DATE: JULY 31, 1997
MODEL YEAR: 1989 - 1997
CHASSIS MODEL: UD1800/UD2000/UD2300/UD2600/UD2800/UD3000
TRANSMISSION MODEL: MLS61A / MLS61B
BULLETIN #: TR - 11
FILE IN THE TRANSMISSION SECTION OF THE TECHNICAL BULLETIN BINDER

MLS61A / MLS61B MAINSHAFT CHANGE

CHANGE NOTICE:

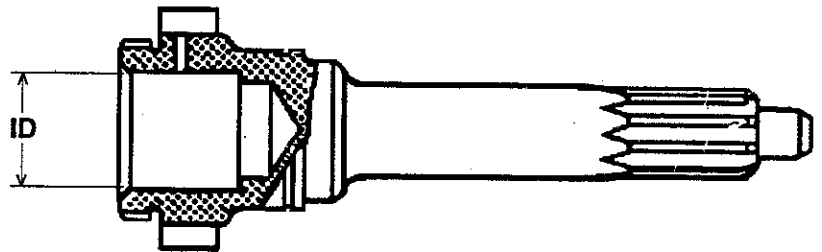
The mainshaft, main drive gear, and pilot bearing for the MLS61A and MLS61B transmissions have been changed as shown below.

PILOT BEARING

Dimensions have changed:

Inside diameter: from 1.18 in. (30mm) to 1.26 in. (32mm)

Outside diameter: from 1.77 in. (45mm) to 1.85 in. (47mm)

MAIN DRIVE GEAR

Inside diameter has changed:

from 1.77 in. (45mm) to 1.85 in. (47mm)

MAIN SHAFT (PILOT BEARING END)

Outside diameter has changed:

from 1.18 in. (30mm) to 1.26 in. (32mm)
